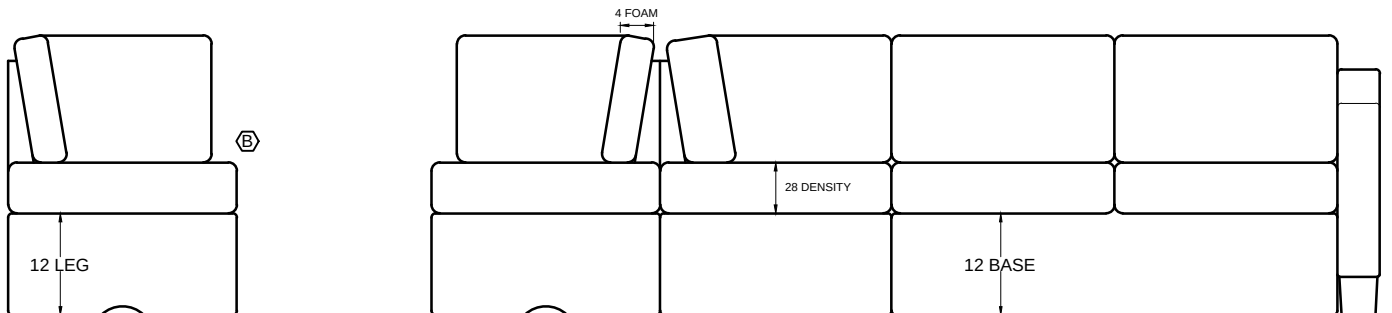
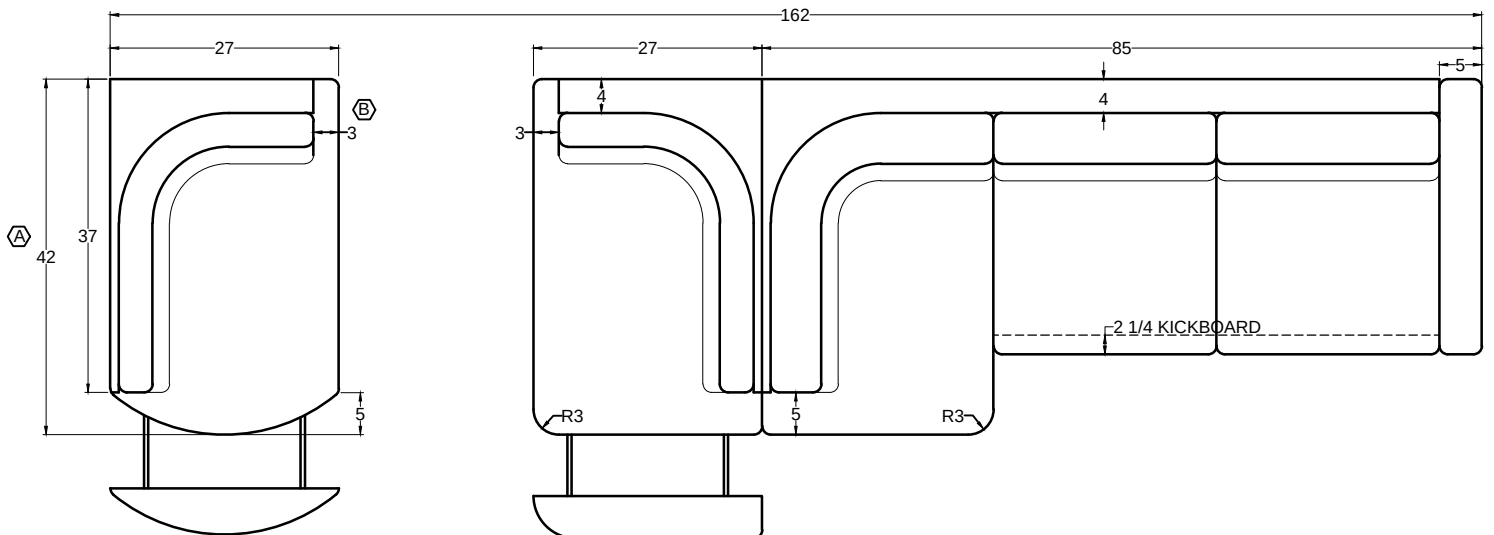
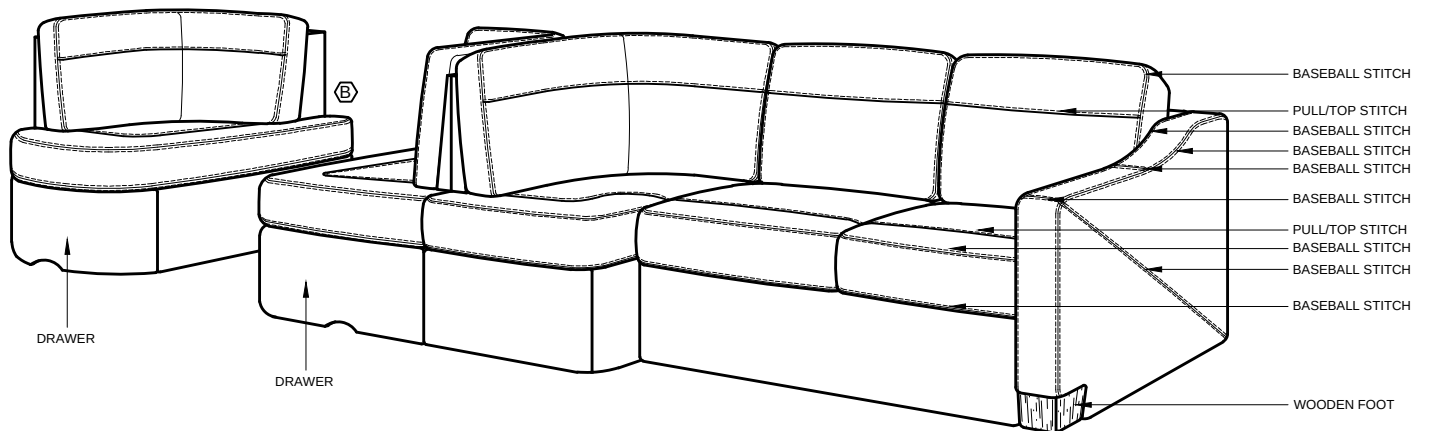
DATE	REQUESTED BY	CHANGE REQUESTED	COMPLETED BY
11.30.15	NHAN N.	CHANGE DINETTE WIDTH TO 42"; WAS 41".	J.ANCHETA
01.07.16	ROBERT L.	ADDED 3" T-CUSHION TO F2F DINETTE.	J.ANCHETA
05.19.16	ROBERT L.	ADDED A RADIUS OF 3 TO CORNERS OF CENTER SECTION.	J.ANCHETA
